CHRONOLOGICAL REVIEW OF W. R. GRACE & CO. PLANT
IN WAYNE TOWNSHIP, NEW JERSEY

We have reviewed the subject draft report; our detailed comments are contained in the enclosure. We are impressed with the amount and apparent quality of the data presented. Our two major comments, which are elaborated in the details, are that more complete presentations of the surface and one meter exposure data are necessary and that clearer conclusions about the actual conditions of the site are necessary. We believe guidelines or criteria should not be discussed in the report. Since we expect that many nontechnical individuals will read this report we have asked for more detailed explanations and clarifications than we normally would in a technical report.

FIGURE 6. Suspected Burial Locations on the W. R. Grace Property.

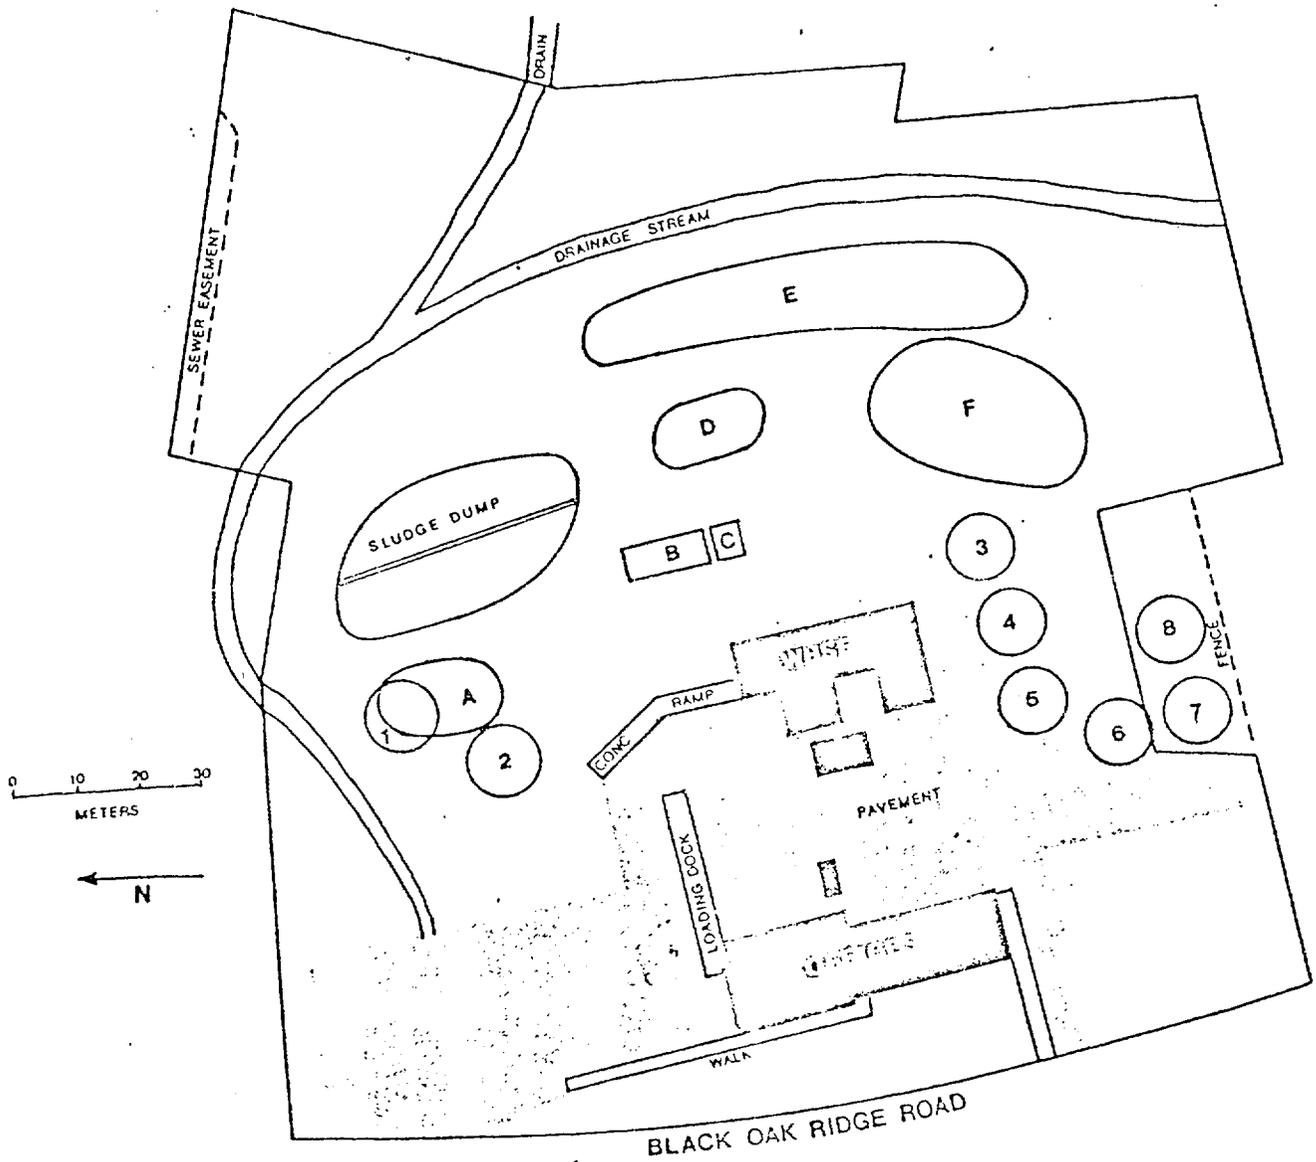
27. page 25, Figure 5 - The words "burial ground" or "burial" are used frequently in the report; it would be helpful if the area referred to was shown or outlined (in color?) on this figure. Revise caption: "1-8 = Circular holes filled April - June 1974 with debris and contaminated equipment resulting from decontamination of buildings."

27. page 25, Figure 5 - The words "burial ground" or "burial" are used frequently in the report; it would be helpful if the area referred to was shown or outlined (in color?) on this figure. Revise caption: "1-8 = Circular holes filled April - June 1974 with debris and contaminated equipment resulting from decontamination of buildings."

FIGURE 10. Borehole Locations on the W.R. Grace Property.

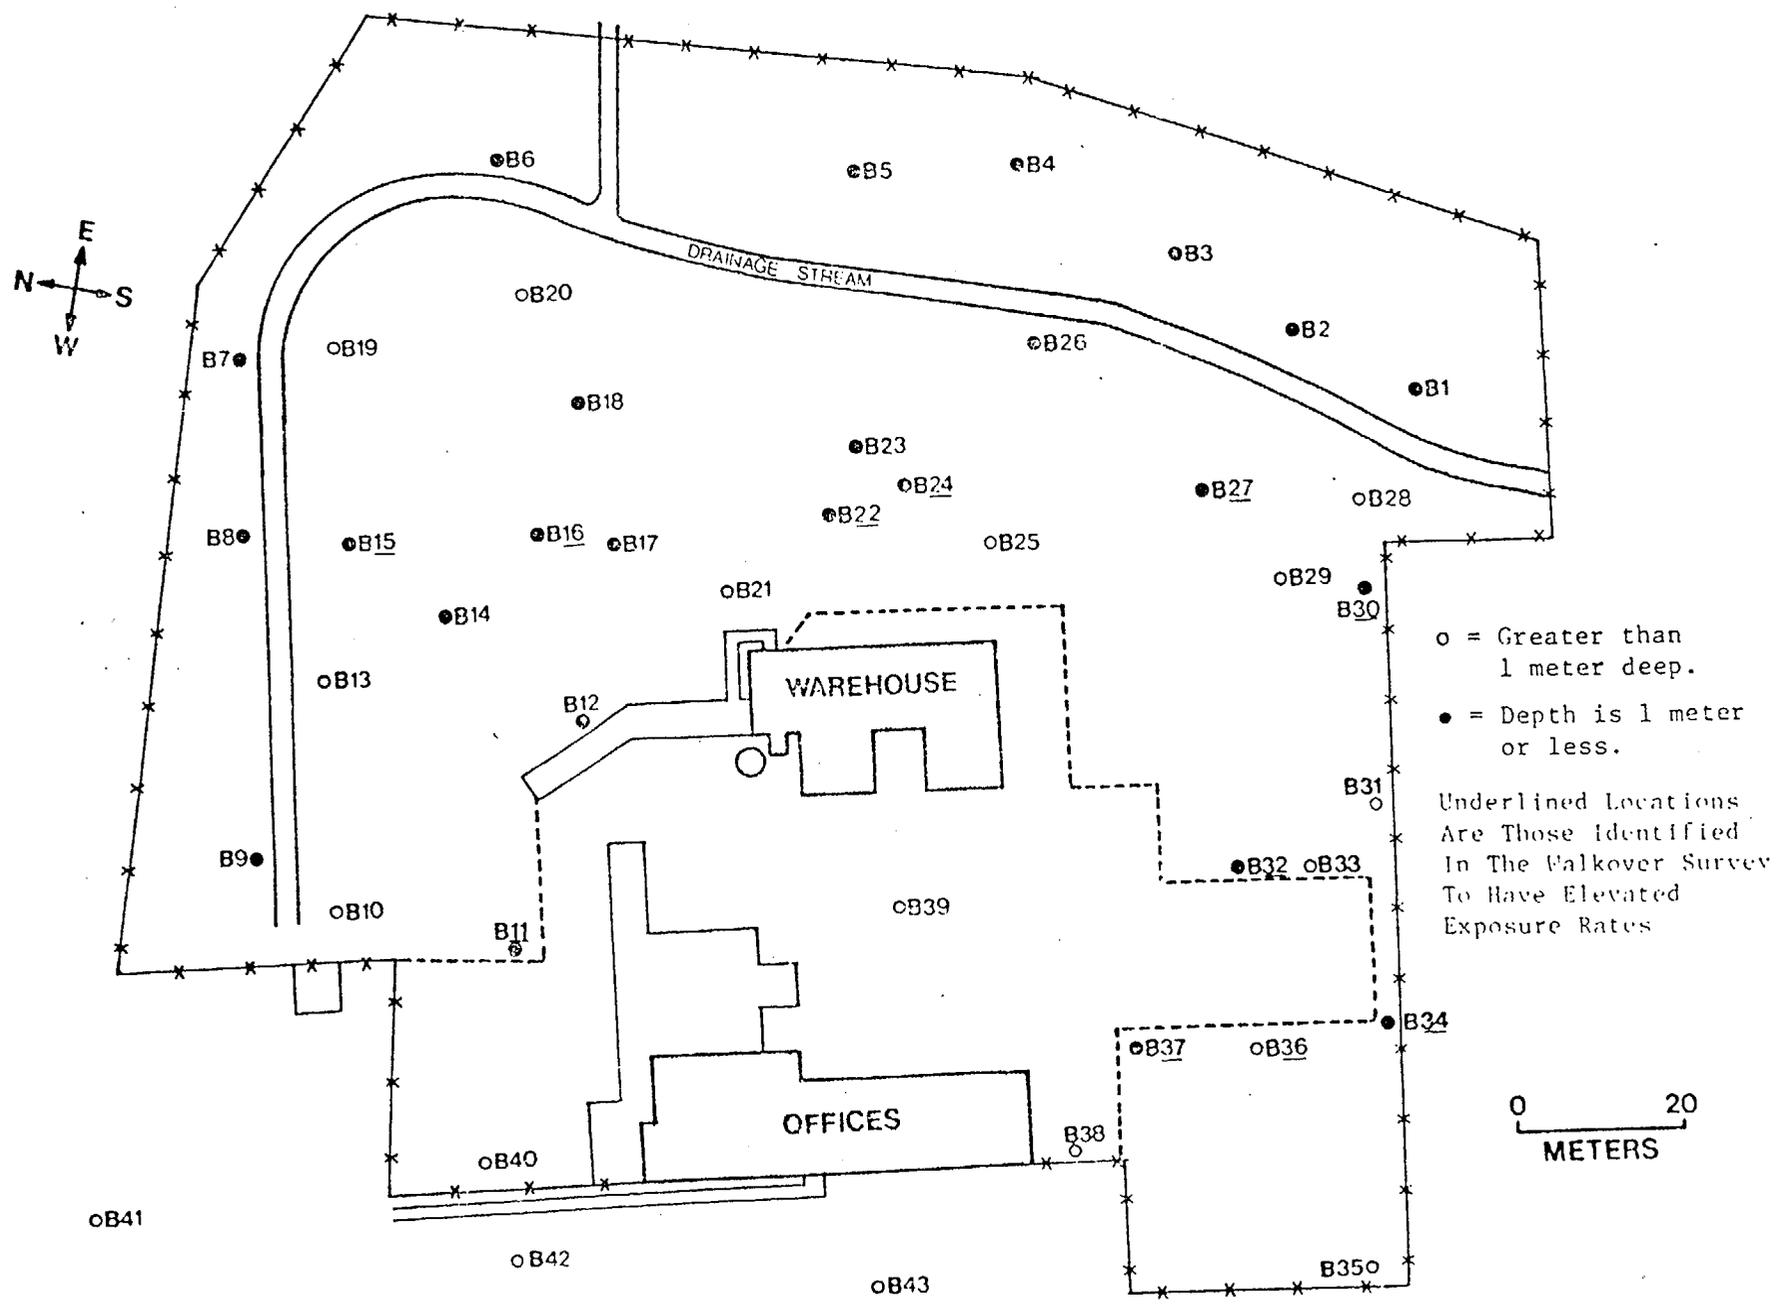
38. page 26, para. 2 - What conclusions did they draw?
39. page 27, Figure 10 is very difficult to read.
40. page 28, Does, "With few exceptions, most of the subsurface objects were detected at an apparent depth of less than 4 feet" mean that no burial is deeper than four feet? We doubt this is true, so it should be explained. The last sentence is an example of the type of clear conclusion which will make the report more useful.

38. page 26, para. 2 - What conclusions did they draw?
39. page 27, Figure 10 is very difficult to read.
40. page 28, Does, "With few exceptions, most of the subsurface objects were detected at an apparent depth of less than 4 feet" mean that no burial is deeper than four feet? We doubt this is true, so it should be explained. The last sentence is an example of the type of clear conclusion which will make the report more useful.
